No. 1246
ATA Code 33-40

SUBJECT: LIGHTS - LANDING LIGHT WIRING MODIFICATION

EFFECTIVITY: BEEHCRAFT Skipper 77, serials WA-1 through WA-312.

REASON: To provide an improved connection for the landing light wire.

Figure 1.

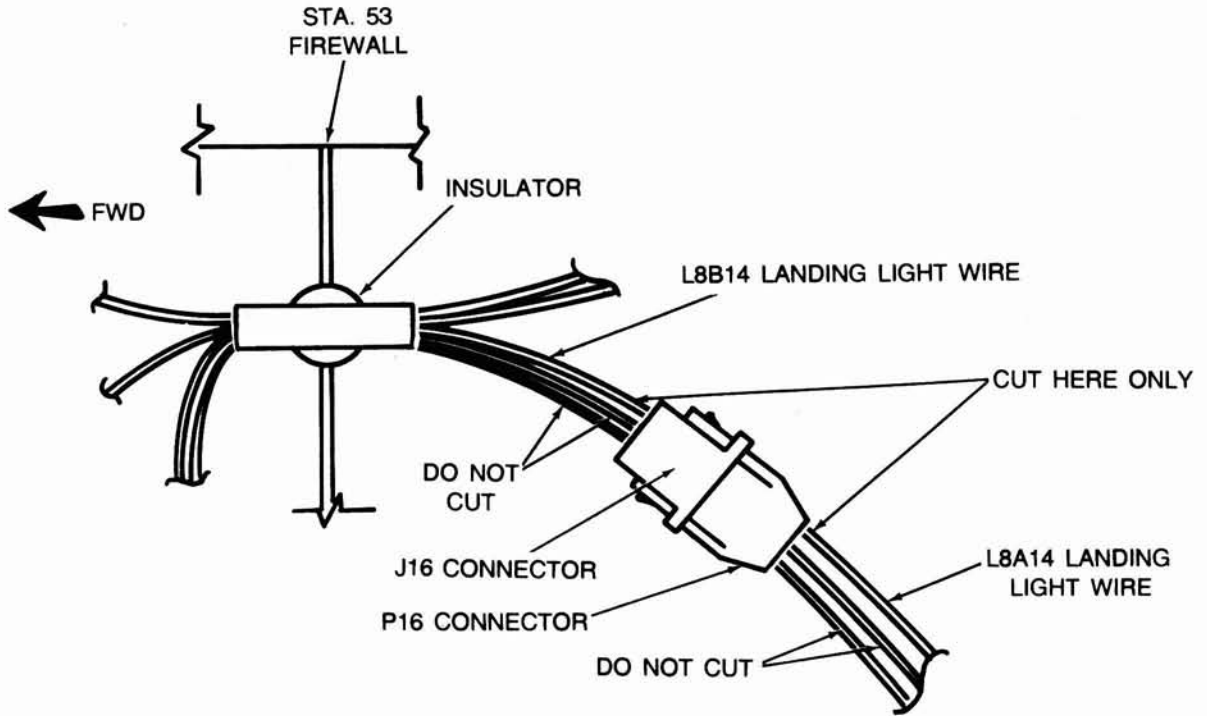
3. Locate the J16 and P16 connectors just aft of the firewall wiring insulator at the upper center of the firewall as shown in Figure 1.

4. Locate the landing light wires, identification numbers L8A14 and L8B14 where they enter the P16 and J16 connectors and cut these wires as close to the connectors as possible to maintain maximum wire length.

Figure 2.

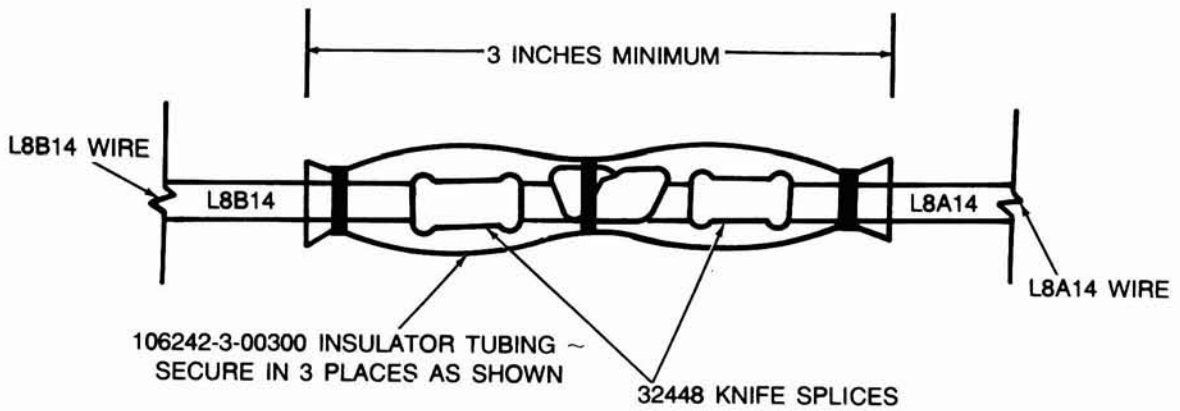
5. Obtain the P/N 106242-3-00300 insulation tubing and trim to a minimum length of 3 inches. Slide the tubing over either the L8A14 wire or the L8B14 wire (see Figure 2).

6. Carefully strip insulation from the ends of the L8A14 and L8B14 wires which were cut in Step 4 and install a P/N 32448 knife splice on each wire.

7. Connect the knife splices and slide the insulator tubing over the knife splices. Secure the insulator tubing in 3 places using P/N TY35M ty-raps (obtain locally) as shown in Figure 2.
